April 18, 2011

To: CA CEC and US DOE Battery Charging Specification Development Teams

Feedback on the Energy Efficiency Battery Charger System Test Procedure Version 2.2, January 26, 2009

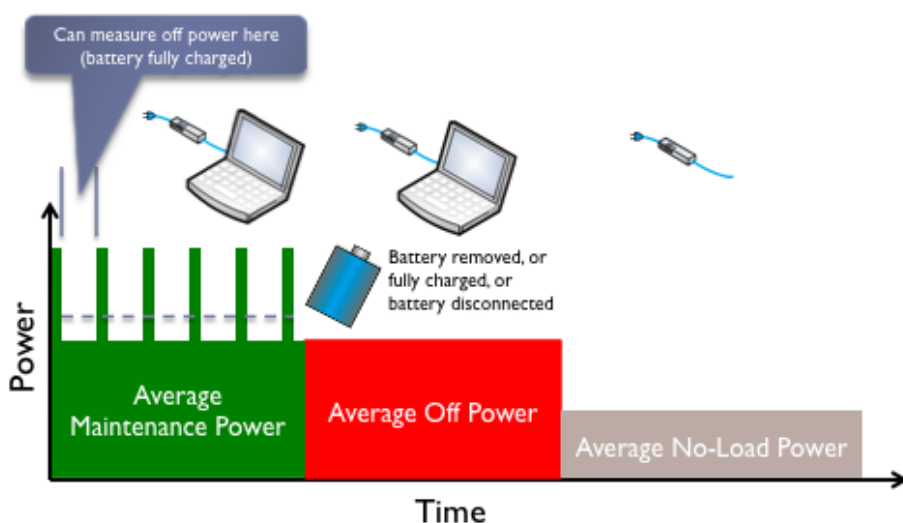
There is a concern for many devices which have integrated battery chargers that the non BCS power (which can't be switched off) will impact the battery efficiency assessments. This is true for Notebook, tablet and cellphone (computer) systems where the level of integration is so high that the ability to shut off these other systems will not be possible.

Additionally, these systems use an EPS where the required efficiencies (via DOE requirements) may not be operating in their optimum efficiency ranges. This is because the rated Pmax of the EPS will be much higher than what is required to charge the battery from an off state (efficiencies are required at an average Pmax of 25%, 50%, 75% and 100% of Pmax).

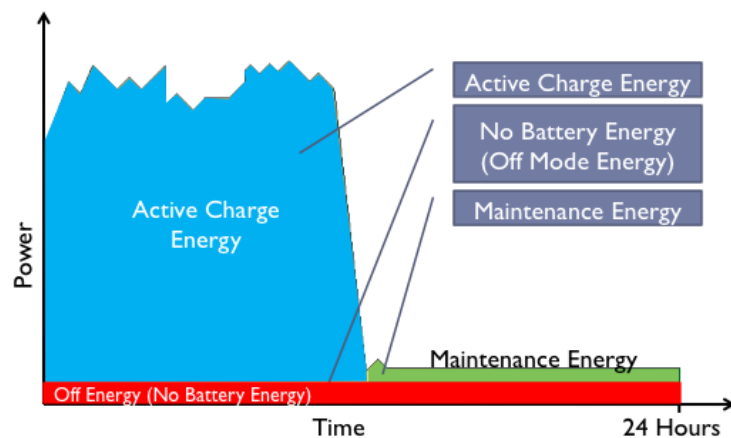
These modes are illustrated in the following diagram depicting the differences between the *Maintenance Power*, *Off Power* and *No-Load Power*.

As highlighted, the *Maintenance Power* and the *Off Power* (i.e. *No-Battery Power*) are different. The intent of the *No-Battery* test is to capture a meaningful representation of the power for system functions. For Category 3 devices, the testing procedure does not capture this, and would estimate a much lower power value using *Average No-Load Power*.

For notebooks, *Maintenance Power* is an issue because this power level varies across the different battery chemistries employed. As a result, it's important to separate *Off Power* from *Maintenance Power* to measure the efficiency of the system. The current test procedure, however, would end up measuring the *No-Load Power* instead of *Average Off Power* or *Average Maintenance Power*.

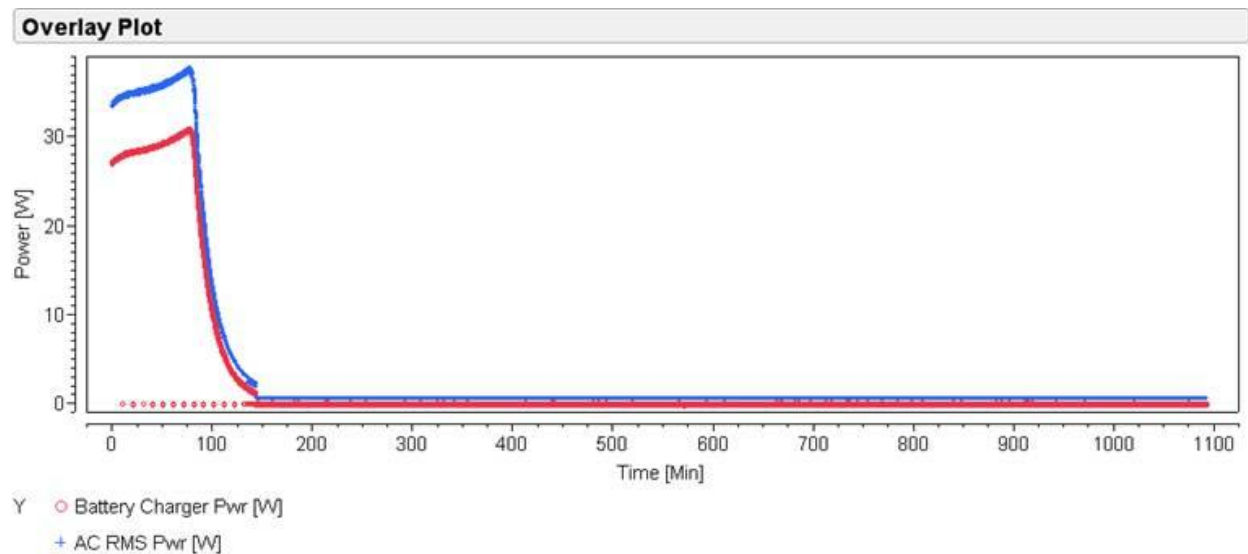
As an example, we recently conducted battery charging tests on a notebook resulting in the following characteristics:

A plot of power versus time (note the red line is the power at the input to the battery charger, blue at the wall) is shown below

This computer system has a Li-ion power, therefore, the maintenance power and off power are approximately the same (Li-Ion have very slow self-discharge rates and maintenance power is not impacted). For non-Lithium chemistries (we didn't have a system to illustrate the point) the off power and maintenance power would be different (Ni-Cd, Ni-MH, etc...). With different power levels for various chemistries, maintenance and off power levels are important to calculate the battery energy (efficiency).
